2.8 Revised Scheme

CAMDEN LOCK VILLAGE
 drawing title / location
 Upper Ground Floor Layout - NMA

Stanley Sidings / AHMM / 14045 / R015 / Hawley Wharf Masterplan / July 2015

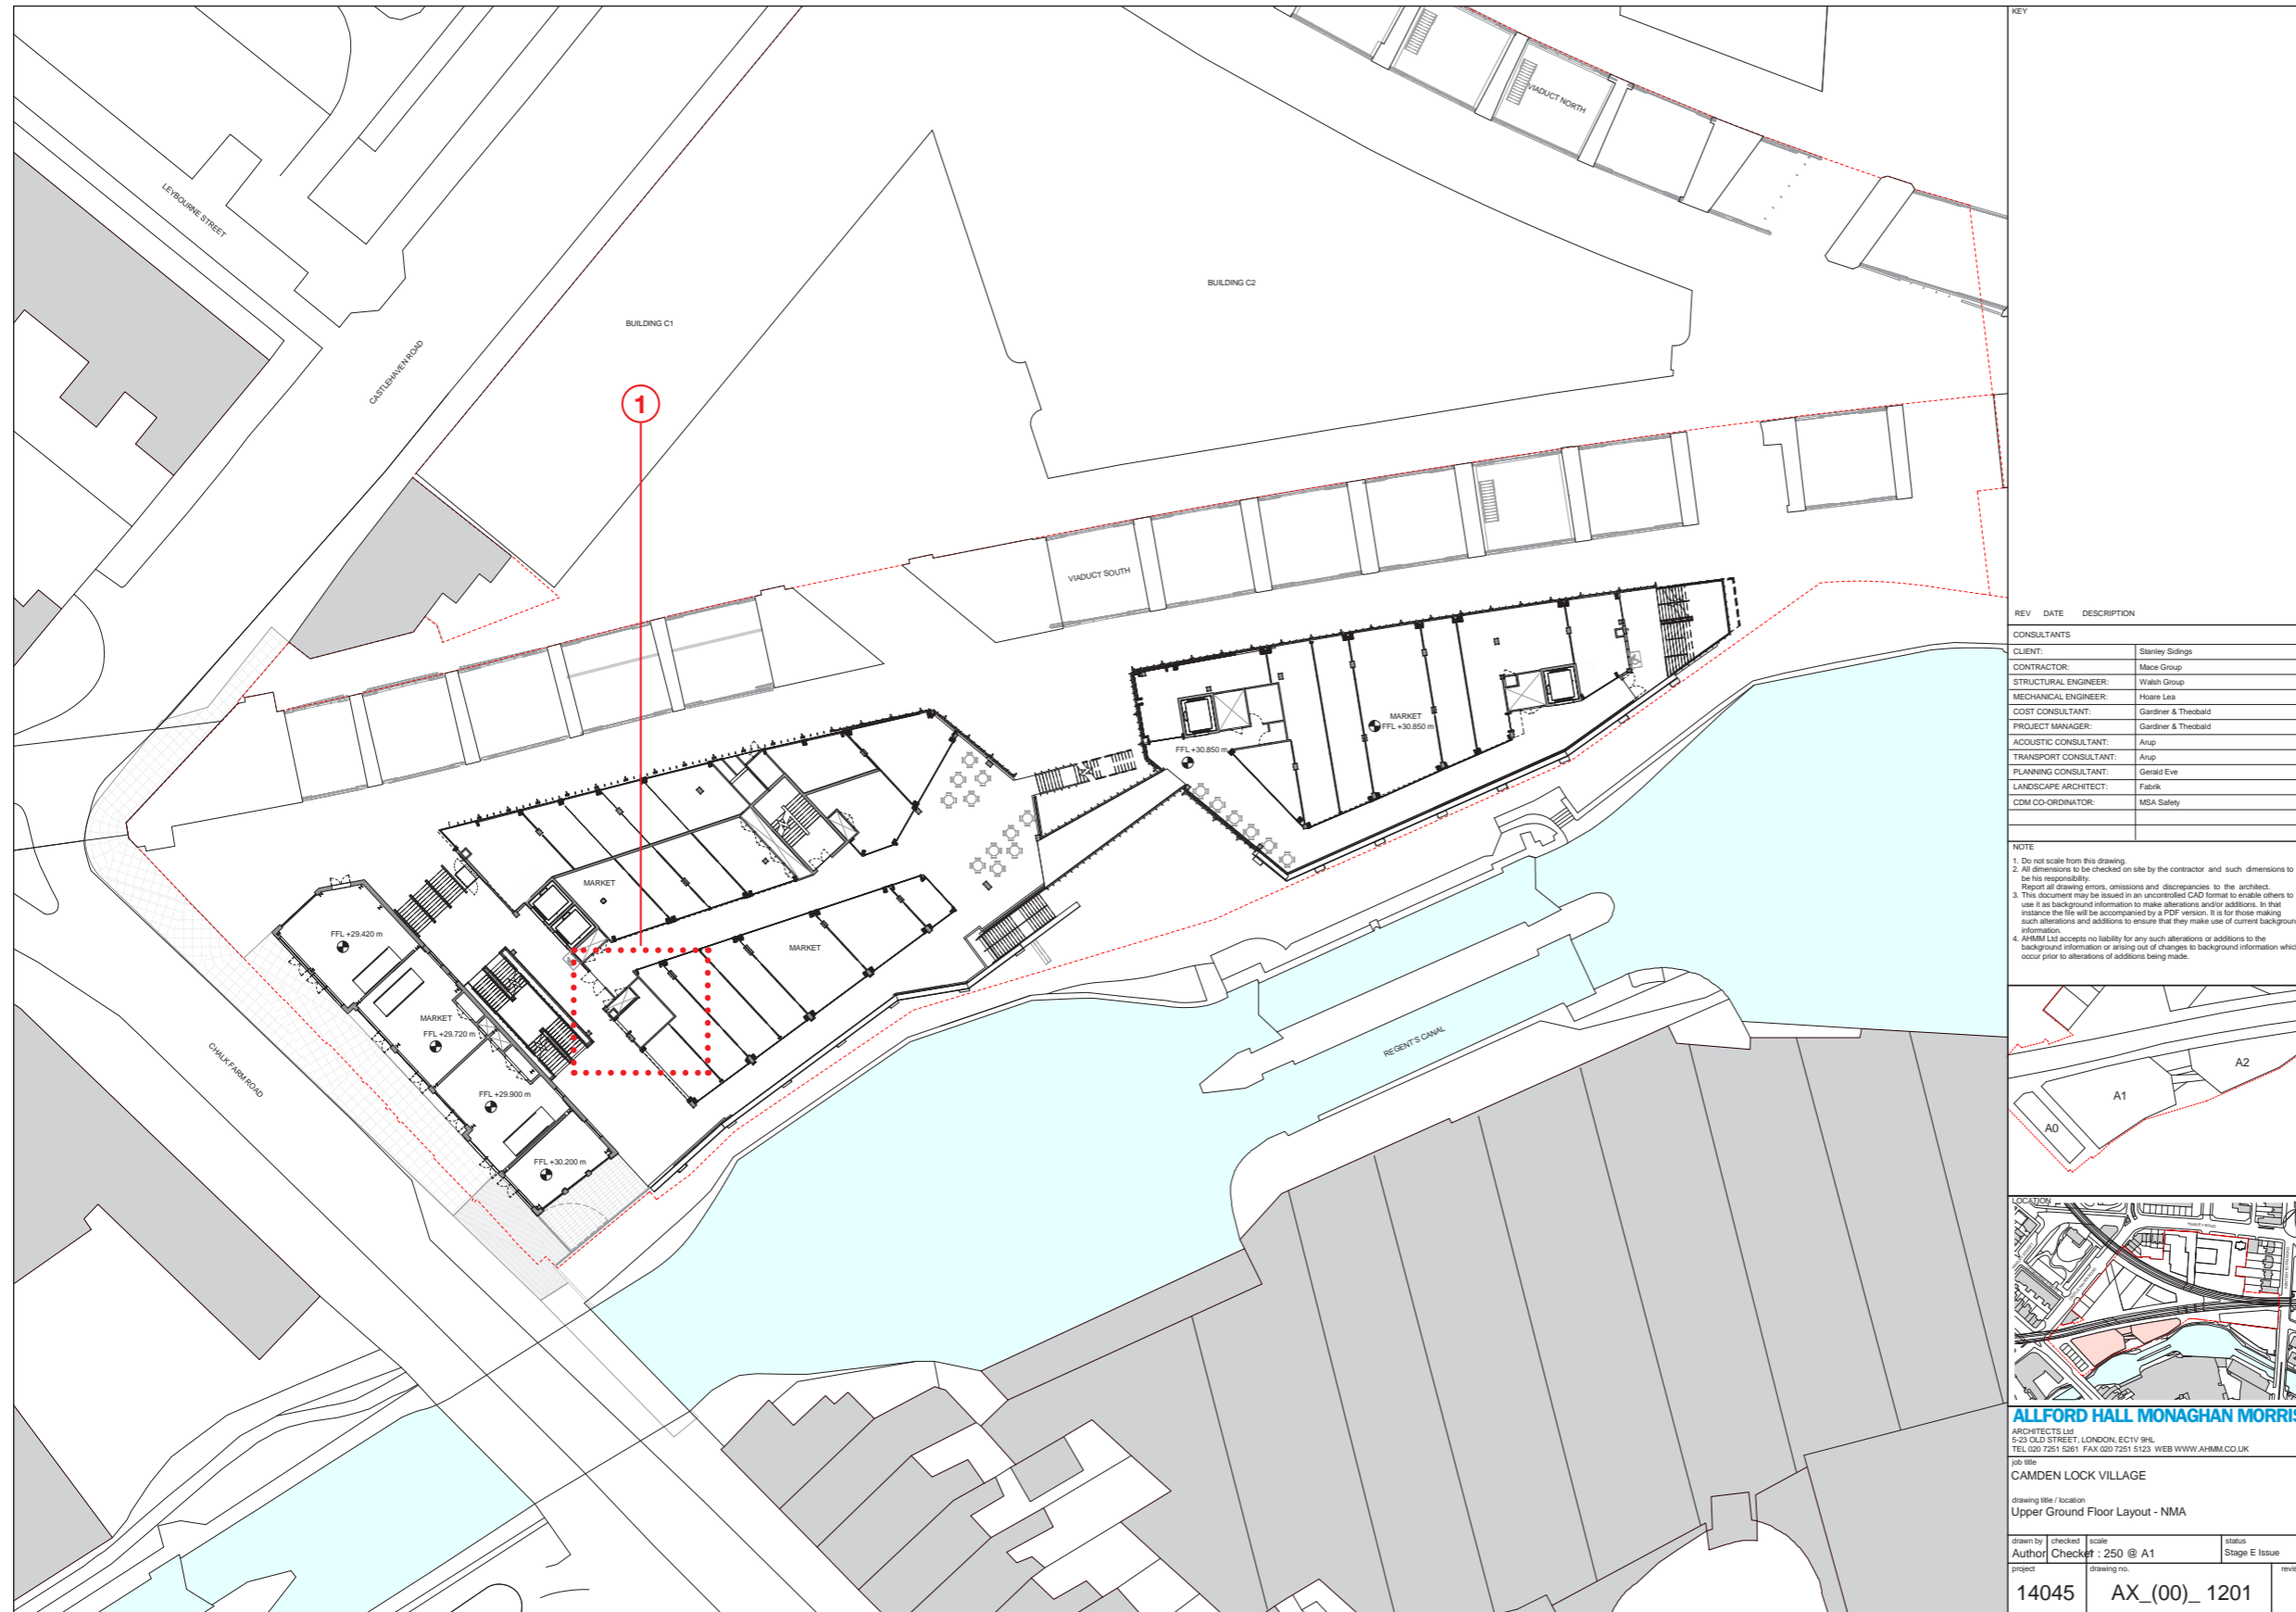
- 1 Relocated mobility shop to improve access into the unit

2.10 Revised Scheme

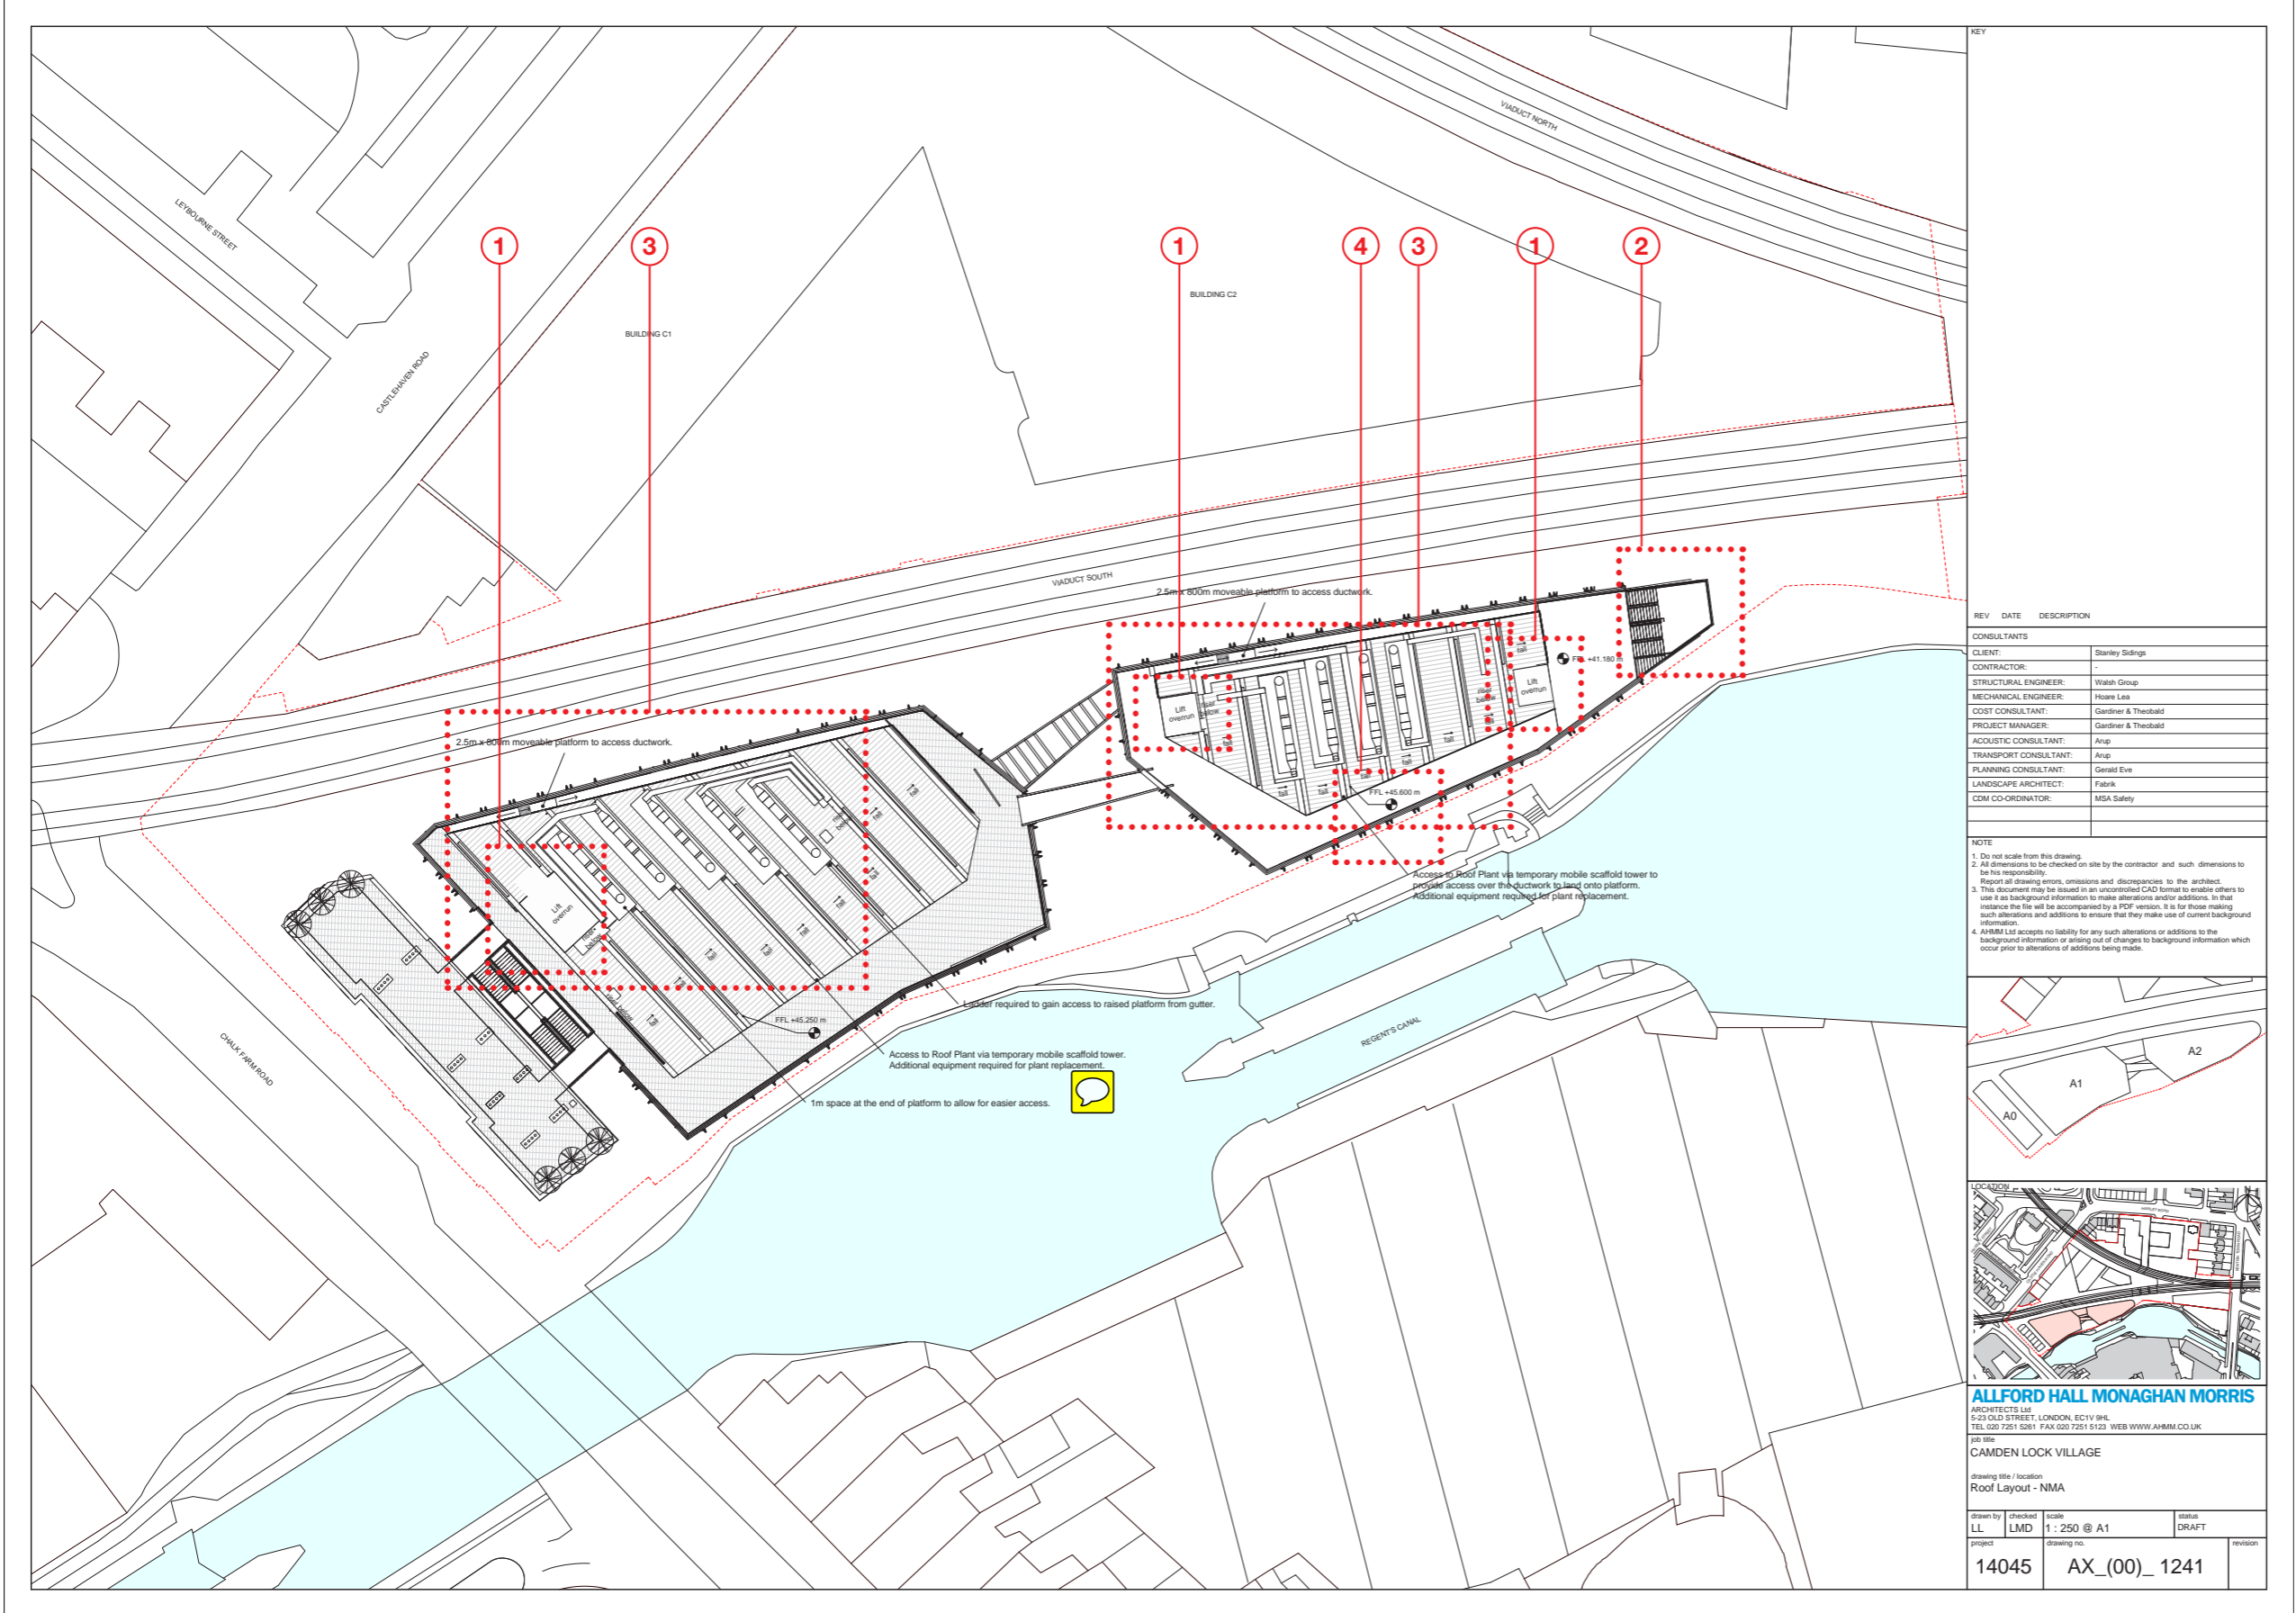
- 1 Lift overruns with required access as a result of detailed design.
- 2 Stair re-configured as part of detailed design to ensure compliance with fire escape and accessibility requirements.
- 3 Roof plant reconfiguration for kitchen extracts as a result of detailed design.
- 4 A2 Levels change (350mm higher) overall to avoid clash with existing National Grid oil lines crossing site.

2.12 Revised Scheme

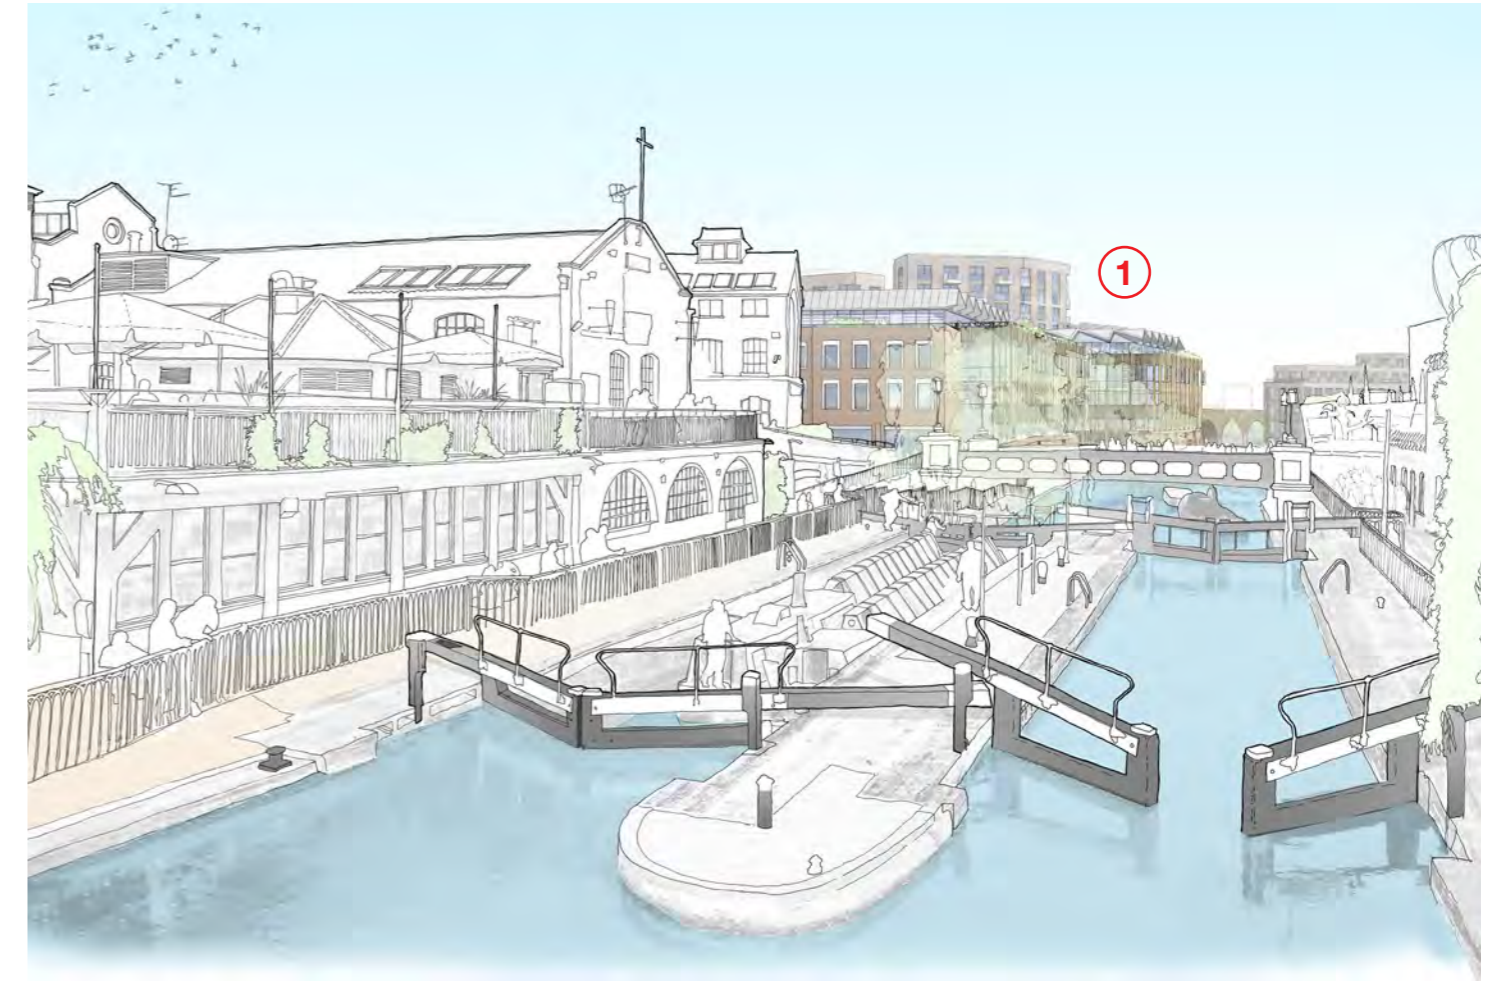
① Updated Rooftop Plant

2.14 Revised Scheme

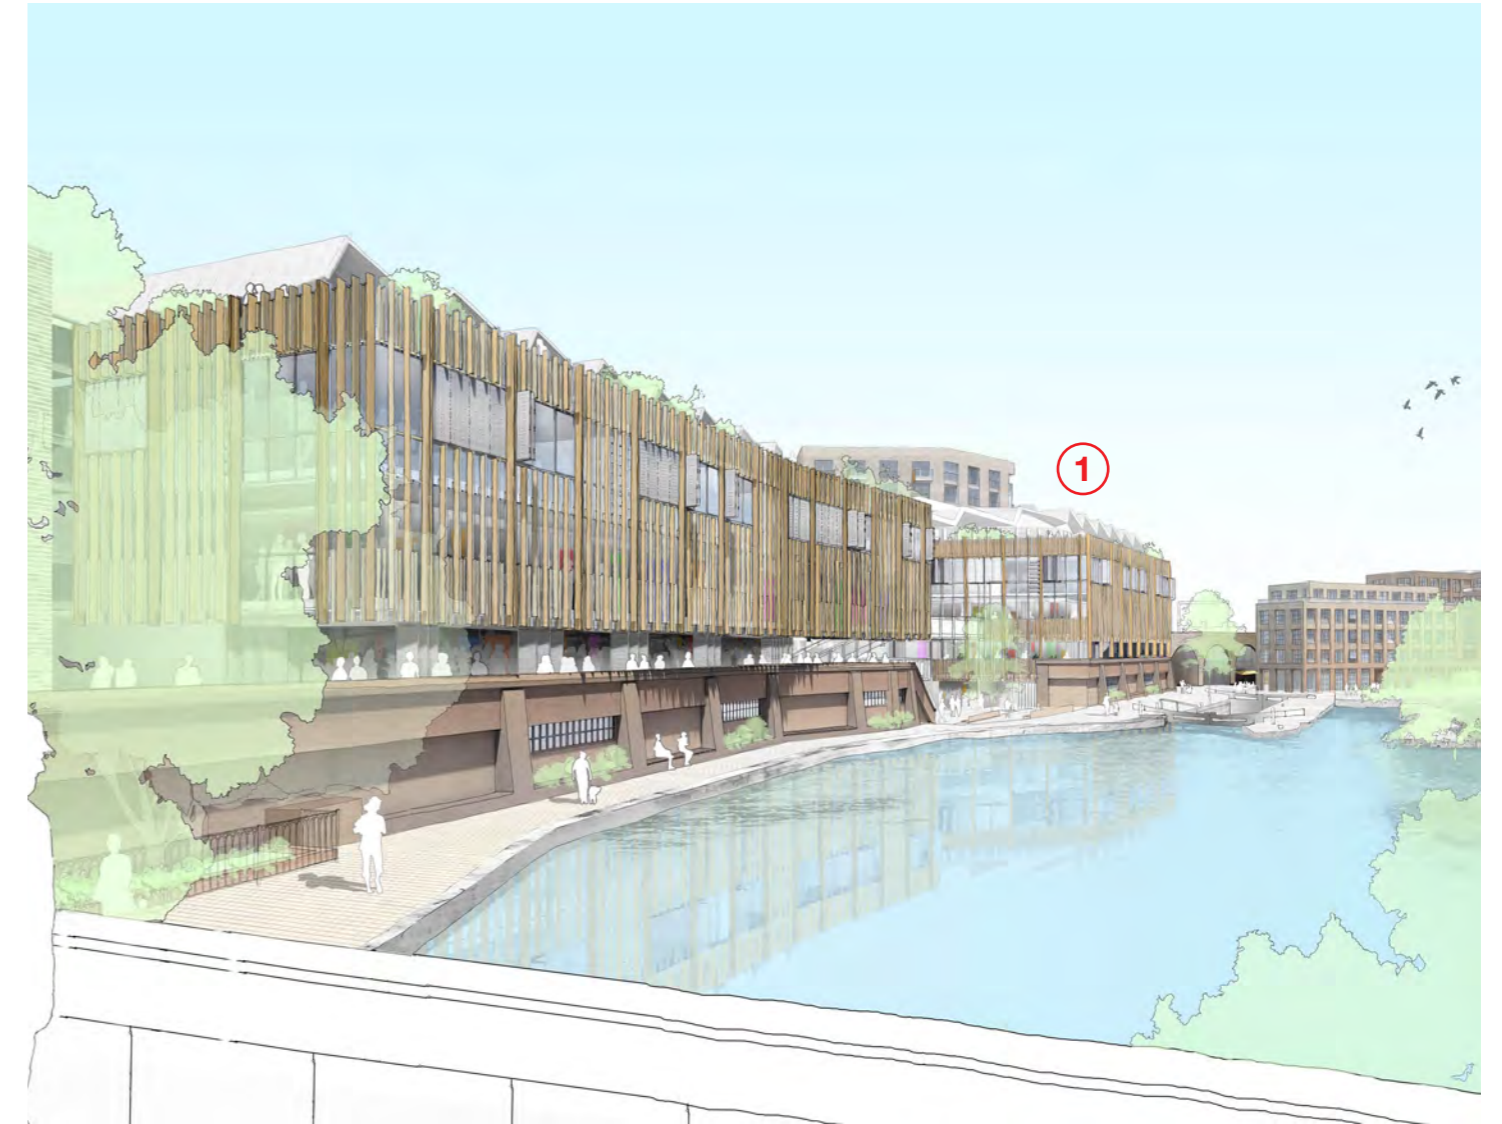
① Updated Rooftop Plant
